5. Development Permit with Variances Application No. 00489 for 2035 Stanley Avenue

Committee of the Whole Report

Subject: Development Permit with Variances Application No. 00489 for 2035 Stanley Avenue

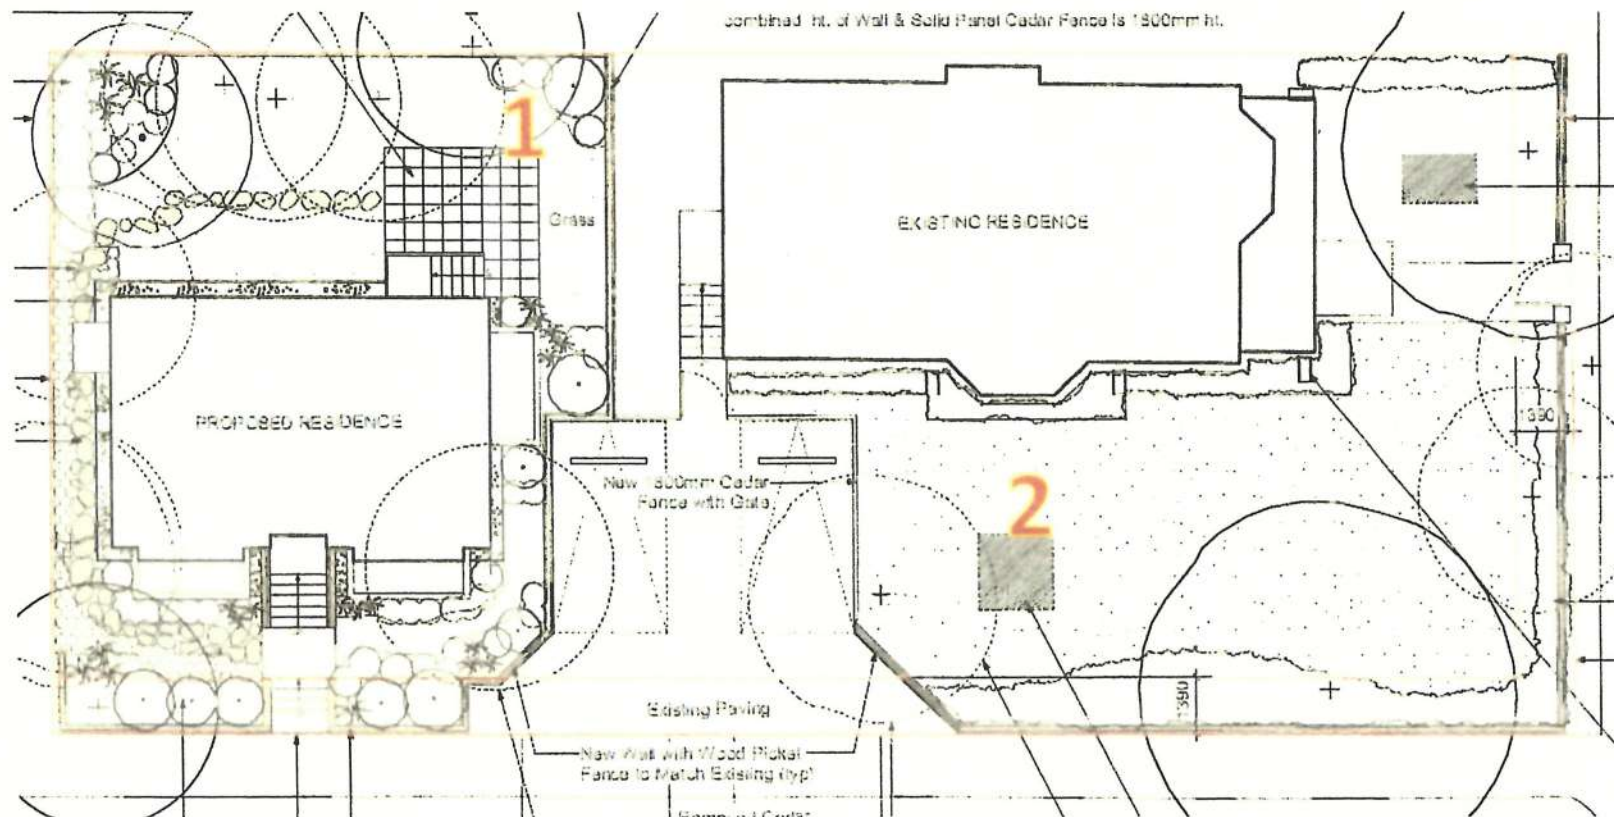
This Site Plan (#1) shows the separation between the houses as more of a side yard arrangement, with the existing residence enjoying a large outdoor space in the northeast of the property (#2)

Title:
STREETSCAPES

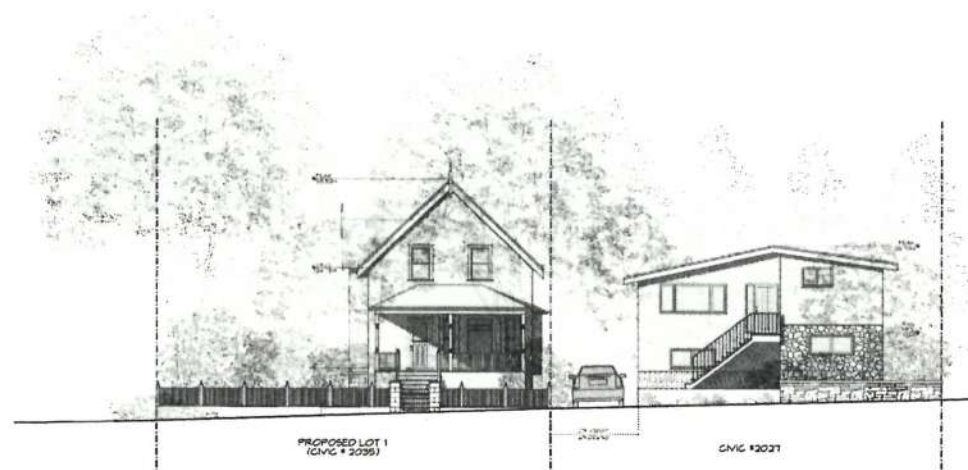
The increased front setback and simplified house design in the revised proposal do improve the relationship to the existing street pattern; however, the siting and massing of the building will still break the established street pattern. The house would still be located much closer to Pembroke

Street than the houses on either side of it. This change in street pattern would appear disruptive and would detract from the visual character and cohesiveness of the streetscape.
